**APPENDIX K
REPOSE TO COMMENTS RECEIVED**

K.0 RESPONSES TO COMMENTS RECEIVED

The Draft Environmental Impact Statement/Environmental Impact Report (DEIS/DEIR) for the Crenshaw/LAX Corridor Transit Project) was circulated to the public for comment over a 45-day review period that concluded on October 26, 2009. Chapter 9.0 of the Final Environmental Impact Statement/Environmental Impact Report (FEIS/FEIR) contains a summary of comments received on the DEIS/DEIR during the public review period, as well as the responses to these comments. Section 15088(c) of the *California Environmental Quality Act* (CEQA) Guidelines describes the evaluation that is required in the response to comments:

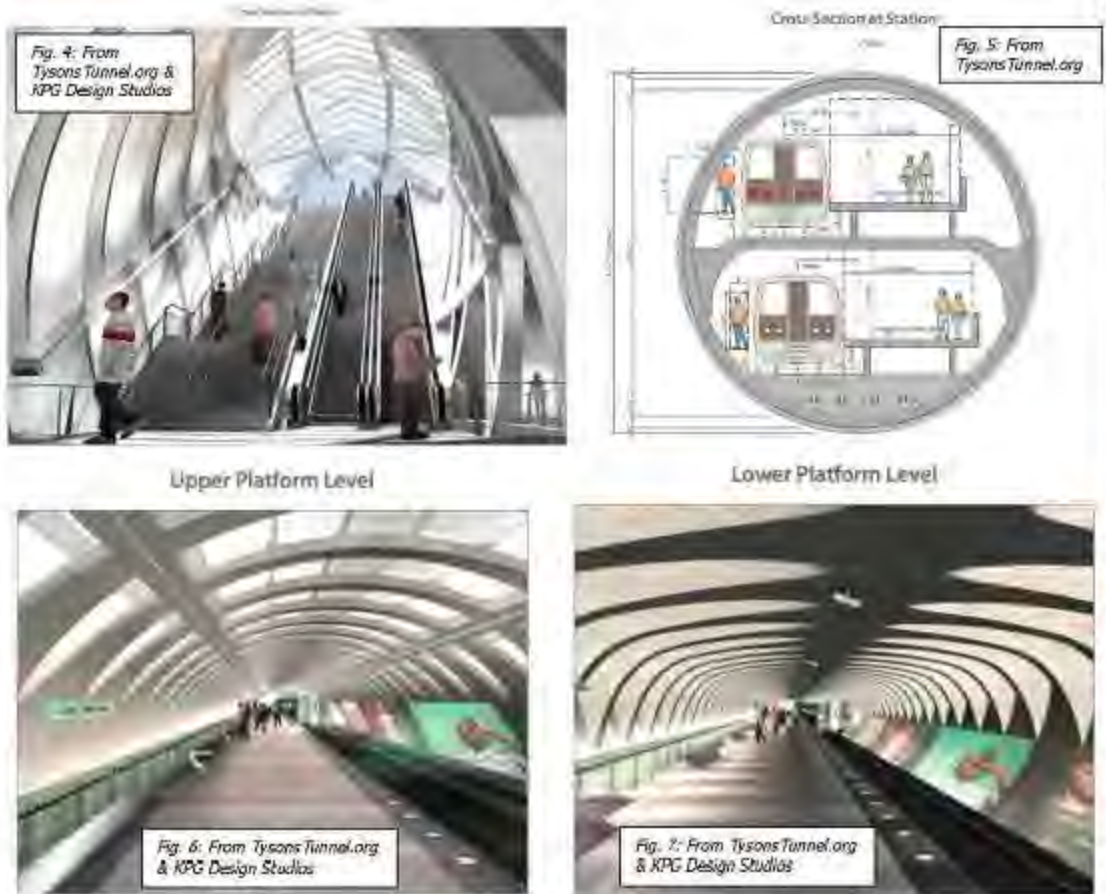
Cut-and-cover may be possible in other wider sections of Crenshaw Blvd, but the avoidable environmental impacts (including, but not limited to traffic, air quality, lengthened construction schedule, loss of mature trees, etc.) of cut-and-cover must be weighed against the environmental benefits and economies of scale of a lengthened bored tunnel.

Single large bore tunnel should be considered.

The DEIR/S fails to consider a large bore tunnel, where one tunnel boring machine is used to construct a single large tunnel for both tracks, as opposed to two smaller separate tunnels with one track each (known as twin bore tunnels). Among other impacts, a single large bore tunnel would mitigate the congestion and air quality impacts associated with crossover construction, which typically requires cut-and-cover construction (the crossover can be constructed within a large bore tunnel). Coupled with reduced required manpower and other benefits, single large bore tunnel often results in a significant overall capital cost savings.
